Re: Resubmittal Sidewalk Waiver _ PR-2023-009652/VA-2025-00023

JLM LIVING WOODMONT AVENUE MODIFIED SIDEWALK WAIVER REQUEST EXHIBIT (1)

JLM LIVING WOODMONT AVENUE MODIFIED SIDEWALK WAIVER REQUEST EXHIBIT (2)

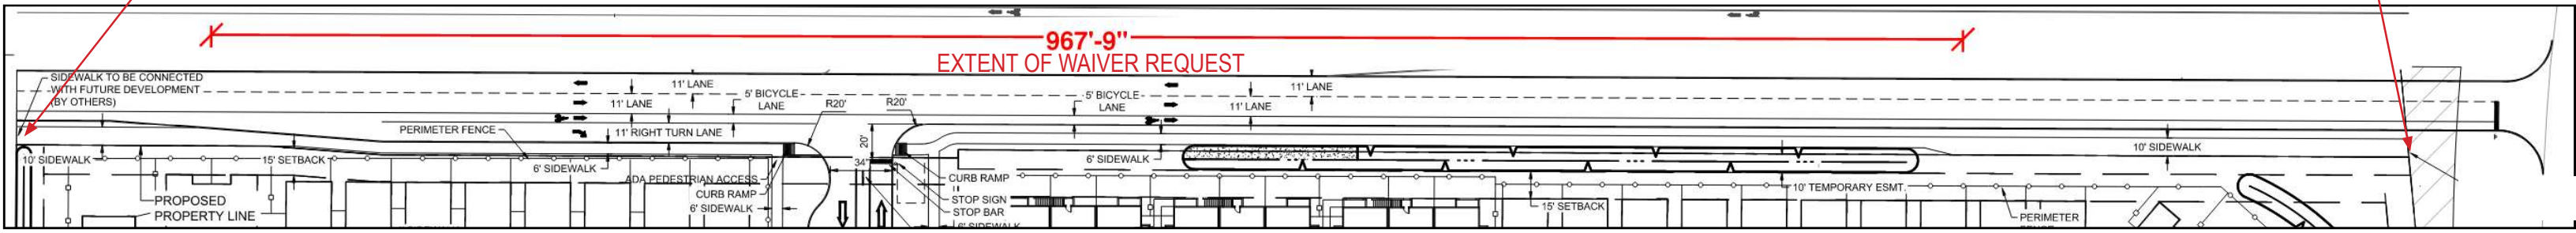
Exhibits showing the revised sidewalk design on the Site Plan and Landscape Plan are included in the resubmittal. As shown, this configuration maintains a walkable sidewalk with the street trees and landscaping requirements along the entire street frontage. This solution maintains the intention of the Urban Center sidewalk requirements and will provide connectivity for future street infrastructure planned for the area.

The sidewalk along Woodmont Avenue shall be constructed to 10 feet, except for the area west of the deceleration lane to the east of the drainage swale (approximately 967 feet), which shall be constructed to 6 feet.

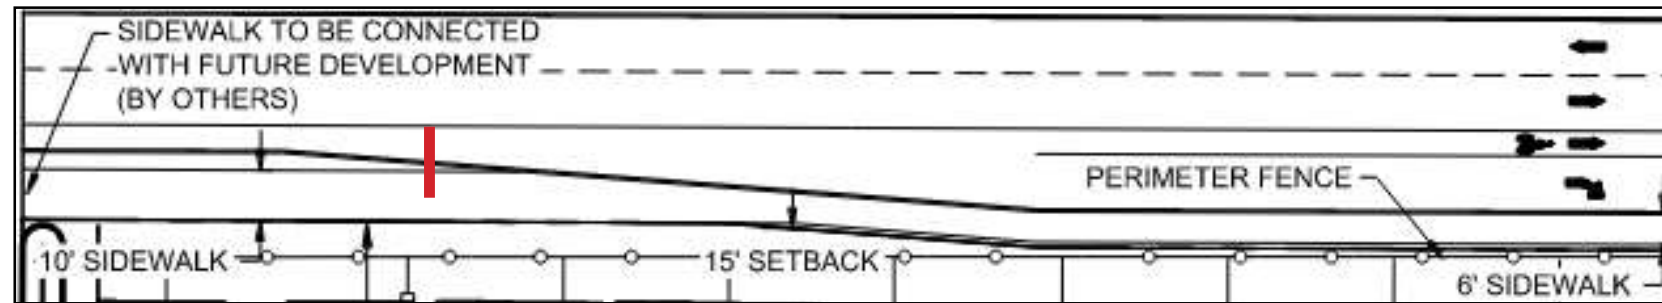
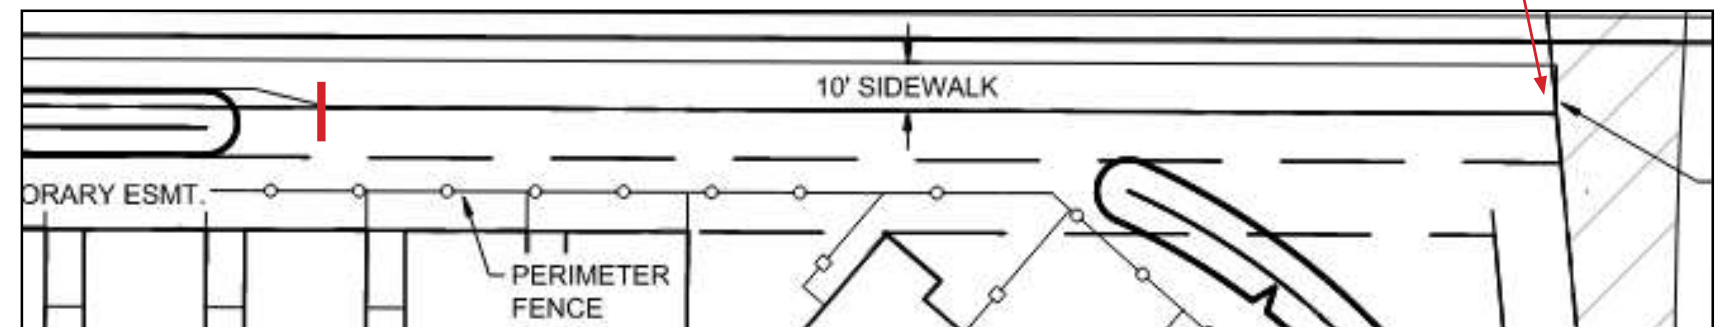
Sidewalk to be connected with future development (by others)

10-foot sidewalk to be connected with future Unser Widening Project multi-use trail

10-foot sidewalk to be connected with future Unser Widening Project multi-use trail

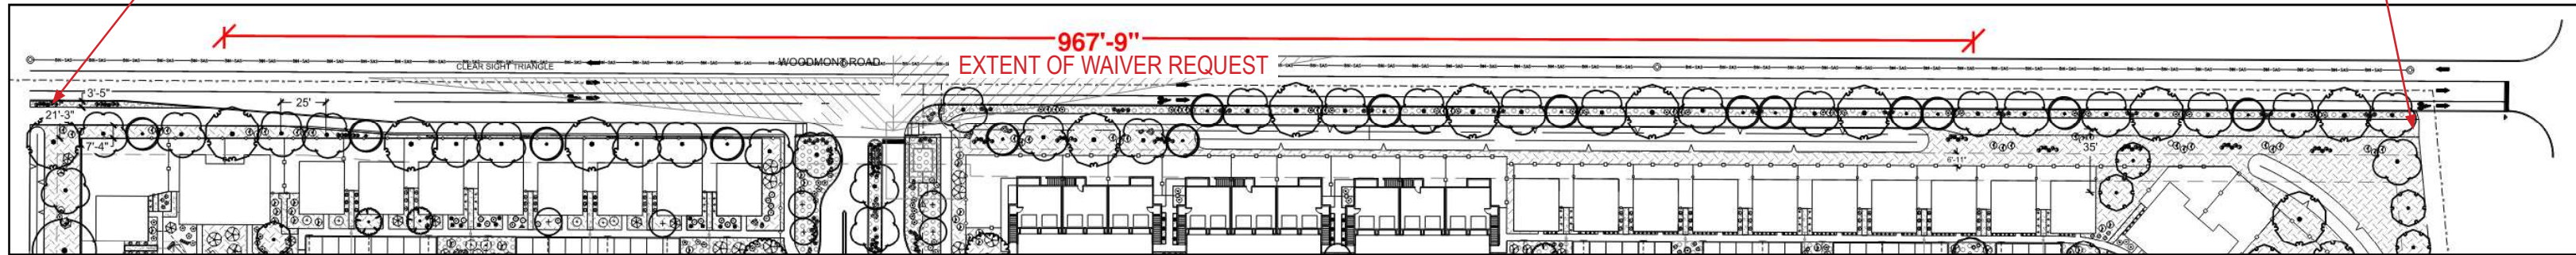
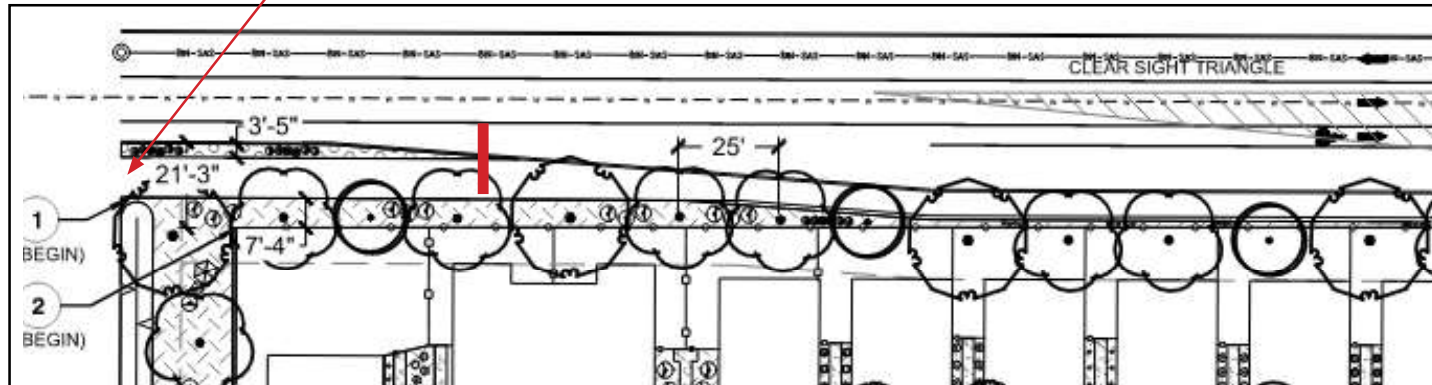
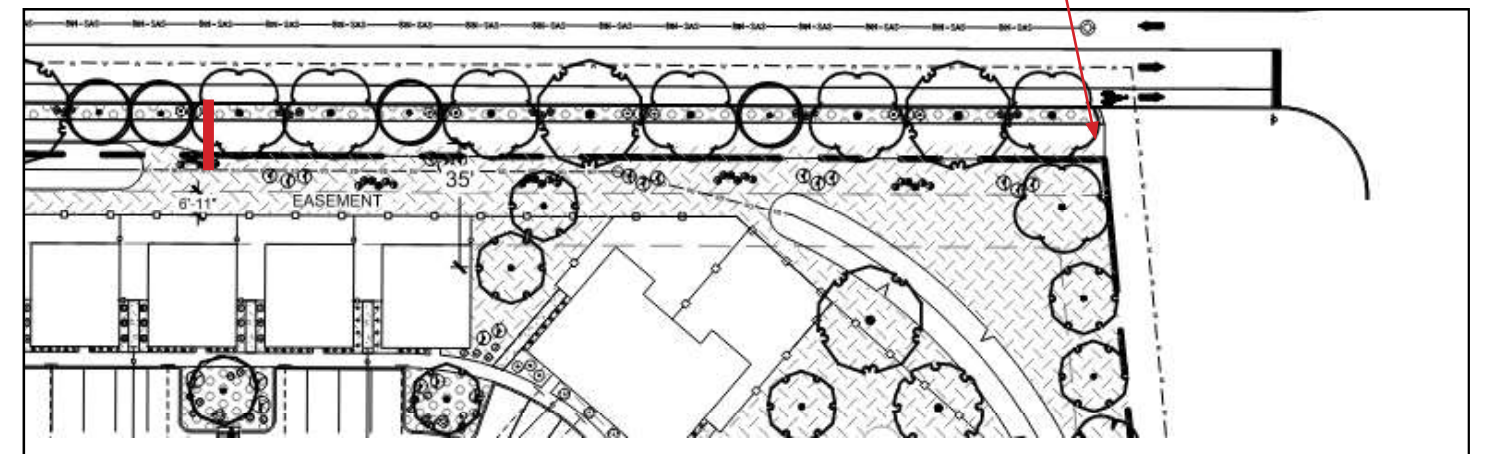
Sidewalk to be connected with future development (by others)

10-foot sidewalk to be connected with future Unser Widening Project multi-use trail

Sidewalk to be connected with future development (by others)

10-foot sidewalk to be connected with future Unser Widening Project multi-use trail
